STATE OF NORTH CAROLINA  
DEPARTMENT OF TRANSPORTATION

**ADDENDUM # 1**

RE: **Plan Sheet Revision and Bid Item Quantity Change**  
Contract ID: DN00261  
County: Cherokee  
Letting Date: January 8, 2019

# CULVERT CONSTRUCTION SEQUENCE STA. 11+81 -L-

County : Cherokee

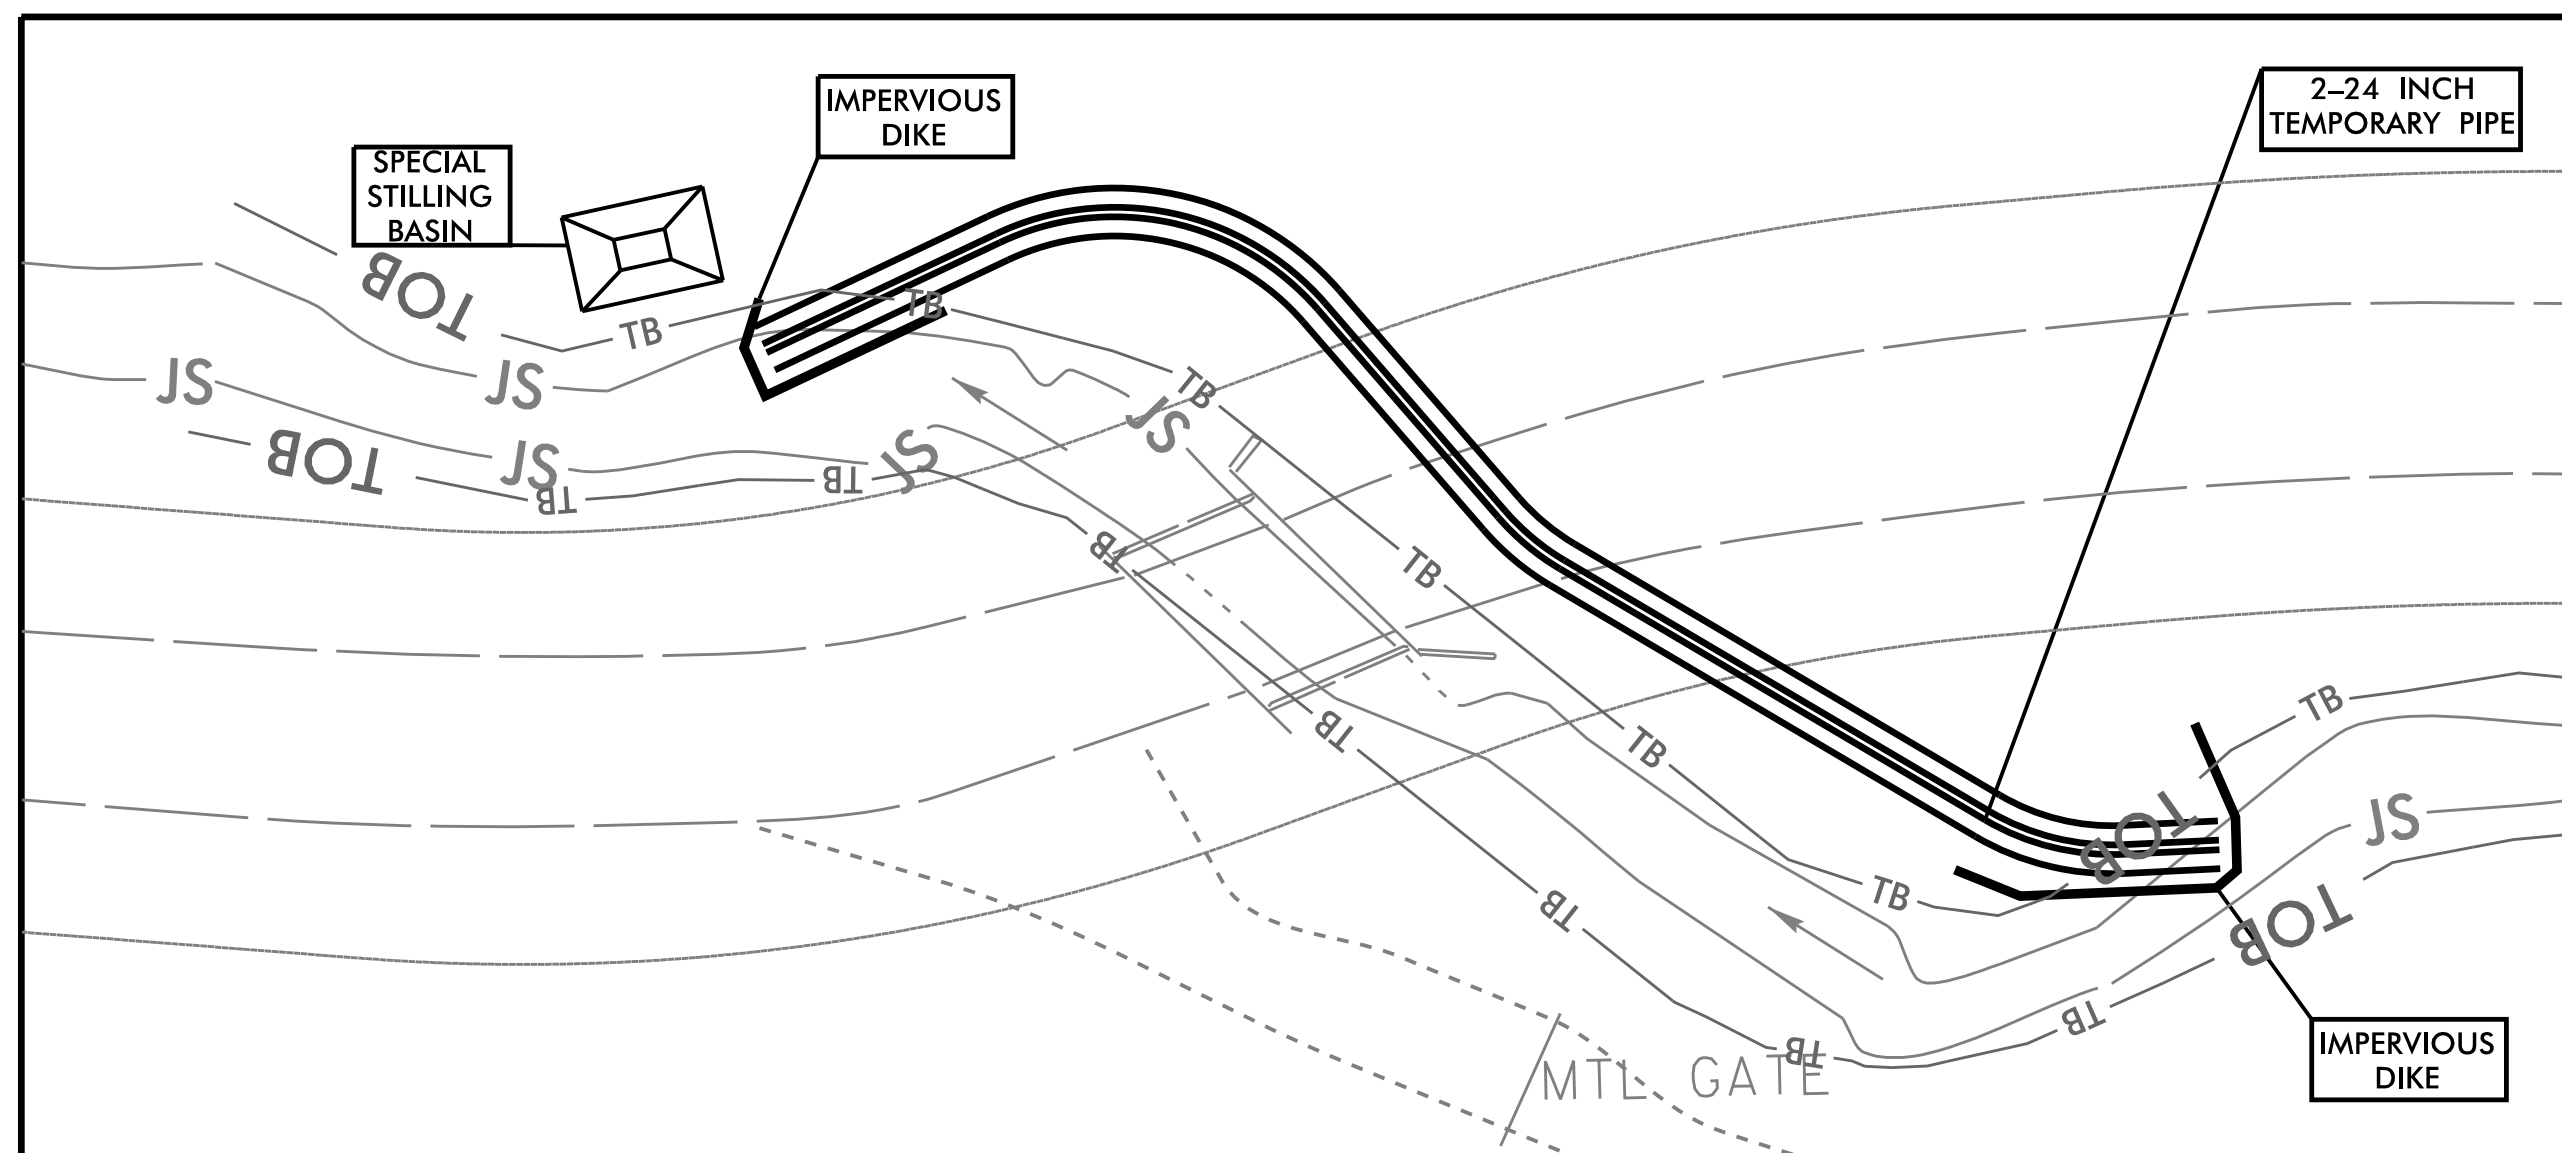
On page T-3 of the proposal, revise line item # **0053 604500000-E SP \*\*\*** **TEMPORARY PIPE (24) 180 LF** to the following:

**0053 604500000-E SP \*\*\*TEMPORARY PIPE (24) 360 LF**

PROJECT REFERENCE NO. <b>17BPJ4.R.86</b>	SHEET NO. <b>EC-7/CONST.4</b>
RW SHEET NO.	
ROADWAY DESIGN ENGINEER	HYDRAULICS ENGINEER

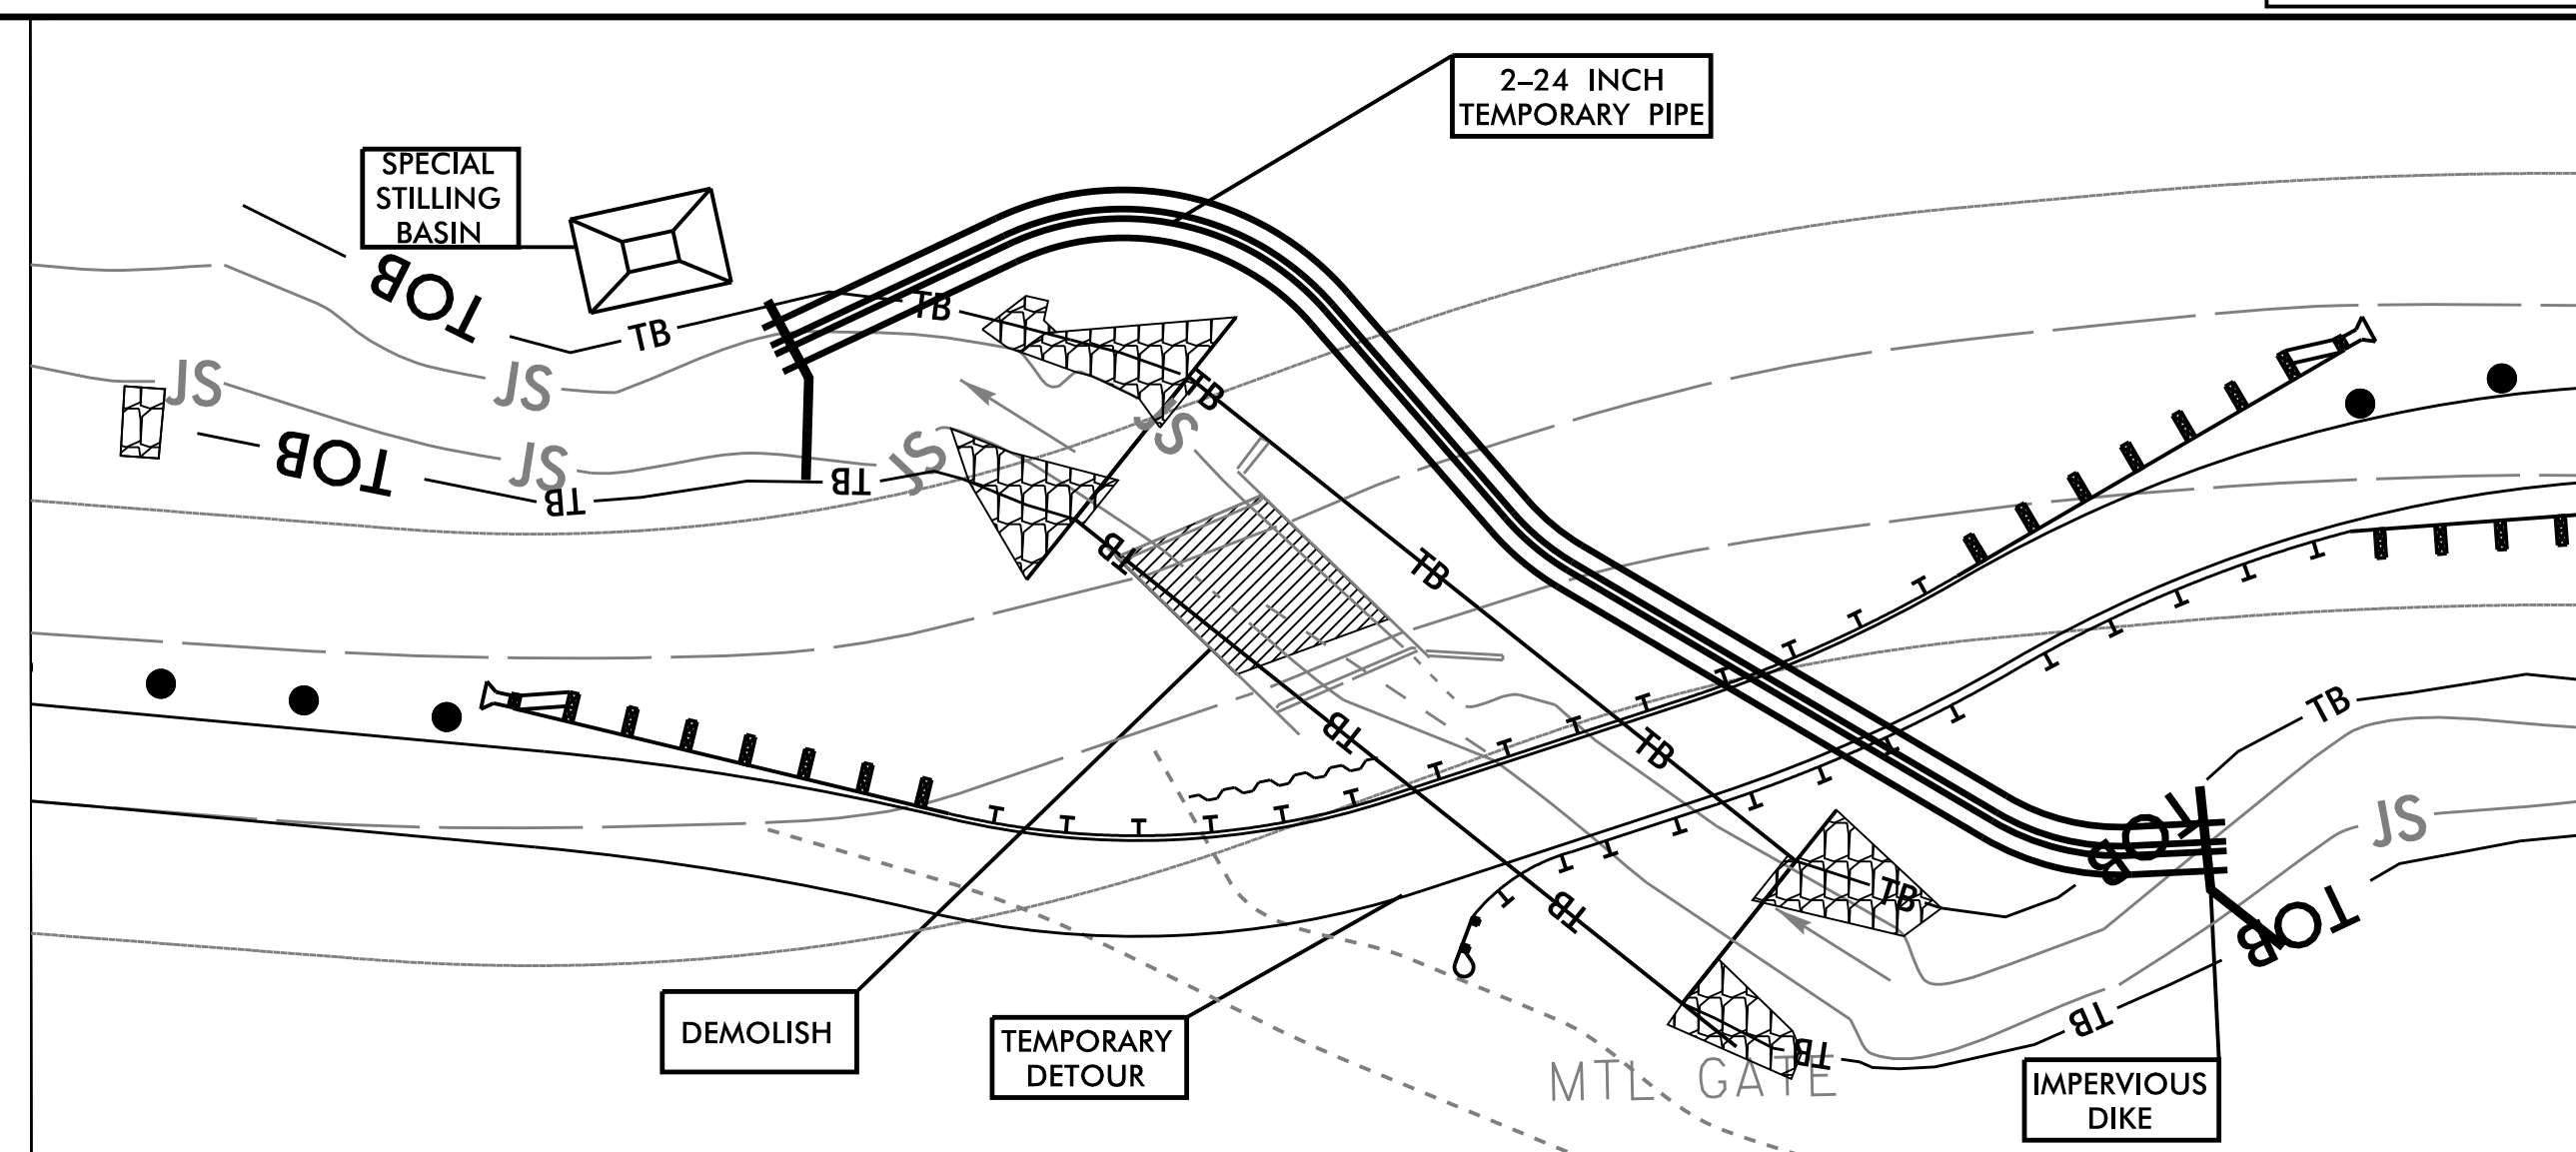
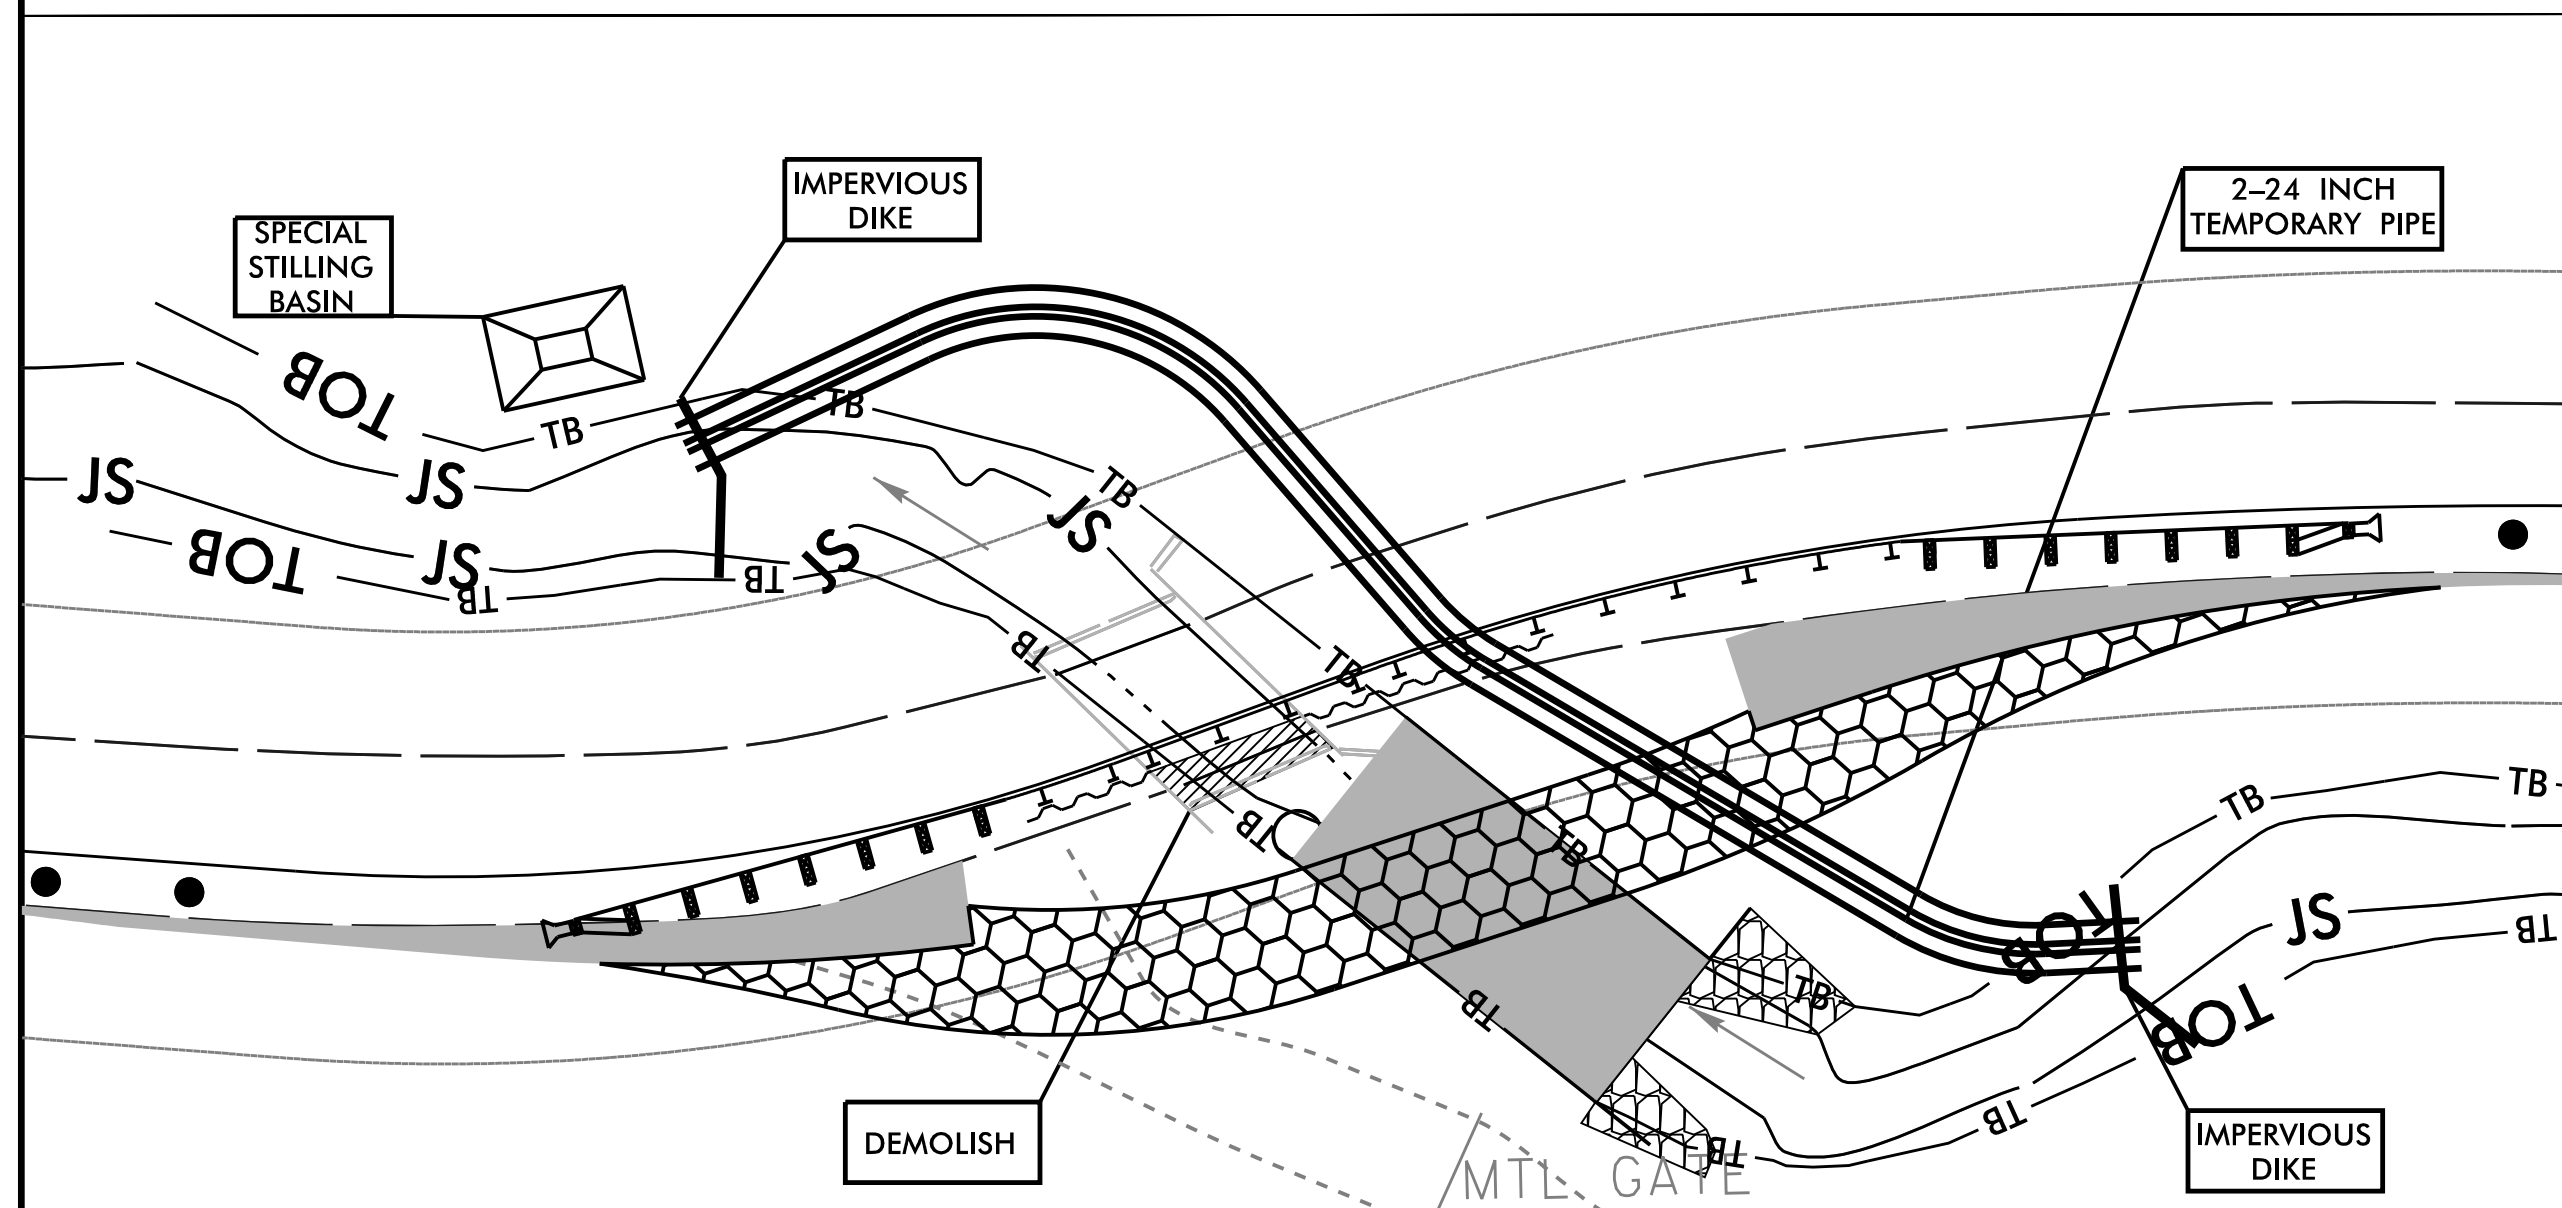
Replace plan sheet EC-7 with the revised sheet EC-7 showing the addition of second 24" Temporary Pipe. See attached plan sheet on third page of this addendum.

1. CONSTRUCT IMPERVIOUS DIKES. DEWATER AREA ENCLOSED INSIDE OF IMPERVIOUS DIKES INTO SPECIAL STILLING BASIN.
2. INSTALL TEMPORARY 2-24" FLEXIBLE PIPE VIA OPEN CUT ACROSS GRAPE CREEK ROAD AS SHOWN AND BACKFILL. DEWATER AREA AS NECESSARY INTO SPECIAL STILLING BASIN.
